Town of Parker Community Development Department
Development Review Division
Attention: **Stacey Nerger**

Application Type: **Site Plan**
Status: **First Referral**
Application Name: Lincoln Professional Park L1 - Maverik
Case/AP#: **SP21-133**
Referral Received: November 24, 2021
Comments Due: December 27, 2021

TOWN OF PARKER - FIRE/LIFE SAFETY:	R REVIEWED FOR CODE COMPLIANCE; REVISIONS REQUIRED
---	---

Note – Items 5, 6, 7, and 8 below will reference the following snapshot of the site:

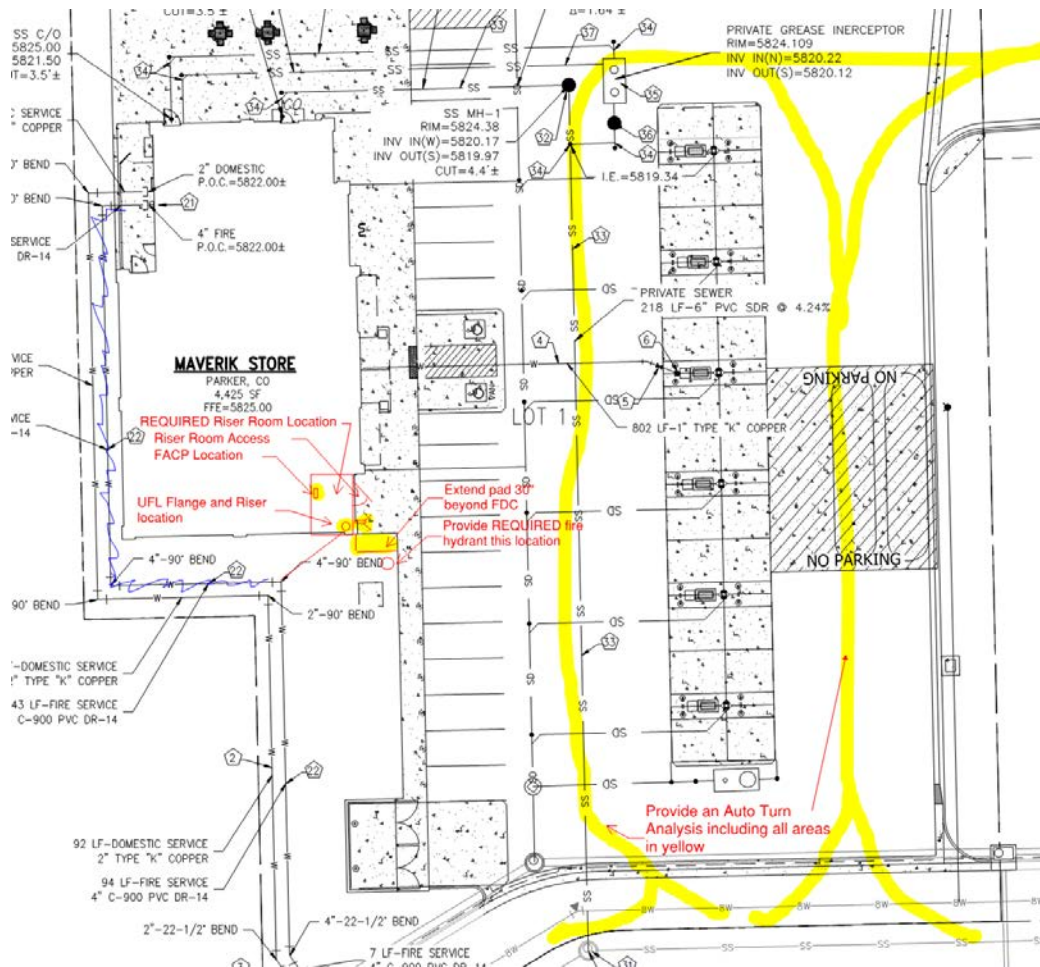
- While the following issue was not addressed (though required in the prior pre-application meeting) the applicant is REQUIRED to locate the fire sprinkler control valve room in the southeast corner of the building. See snapshot above for additional information. ***Partially satisfied; applicant has not acknowledged this issue with the required response to this letter though the riser room has been relocated to a mutually acceptable location and the utility drawings modified. Not satisfied; applicant has not acknowledged with third submittal. Applicant shall address when resubmitting.***
Maverik response: Acknowledged. Riser room has been moved to an acceptable location.

- While the following issue was not addressed (though required in the prior pre-application meeting) the applicant is REQUIRED to provide a room layout ensuring that the fire sprinkler control valve room is sized to accommodate the following:

- Exterior access is required into the riser room with access into the building provided either adjacent to the riser room or through the riser room.
- The FACP will be required to be located in the fire sprinkler control valve room; ensure that the riser room is sized to accommodate the FACP and the riser. A three-foot clearance is required in front of the FACP as well as the sprinkler riser (as well as the three foot 18" to center of FACP/riser... each side.
- The underground fire line shall enter the building and turn up no further than 24 inches from foundation wall; three feet of clearance is required in front of the fire riser.
- The FACP shall be located on an interior wall.
- A 5'x5' pad is required in front of the FDC.
- A sidewalk is required to both the FDC location and the riser room

The riser room layout shall be provided in advance to assure that all requirements are met. See snapshot above for additional information. *Partially satisfied; applicant has not acknowledged this issue with the required response to this letter though the applicant has provided a Fire Riser Exhibit. The exhibit does not address the domestic that is shown to enter the room adjacent to the riser. When resubmitting, address this issue to ensure that there will not be conflicts with the domestic and the fire riser down the road. Not satisfied; applicant has not acknowledged with third submittal. Applicant shall address when resubmitting.*

7. While the following issue was not addressed (though required in the prior pre-application meeting) the applicant is required to provide a fire hydrant interior to this site; the applicant shall provide a fire hydrant in the island at the southeast corner of the building... as required per NFPA 24, Section 7.2.3 (this section states that a fire hydrant shall be located not less than 40' from the building to be protected. See snapshot above for additional information. Note – Fire hydrants are required at each entry to the side; off Dransfeldt and off of Lincoln with spacing provided as directed at previous meetings. *Partially satisfied; applicant has not acknowledged this issue with the required response to this letter though the utility plan set addresses this issue. Not satisfied; applicant has not acknowledged with third submittal. Applicant shall address when resubmitting.*
Maverik response: Acknowledged.

8. The applicant shall provide an auto turn analysis indicating that apparatus can navigate all portions of this site (both sides of the gas canopy); NO PARKING – FIRE LANE signage is required for any portion of the access where the 20-foot clear width requirement cannot be met. This is applicable for the loop around the canopy as well as for each entry. The access on each side of the canopy shall meet his requirement with no portion of the canopy encroaching into the required fire lane access road. See snapshot above for additional information. *Not satisfied; applicant has not addressed/noted/acknowledged with second submittal. Applicant shall address when resubmitting... providing the auto turn analysis in the process. Not satisfied; applicant has not acknowledged with third submittal. Applicant shall address when resubmitting.*
Maverik response: Acknowledged. Turning template provided. See fire access Exhibit

Maverik response: These have all been addressed and acknowledged.
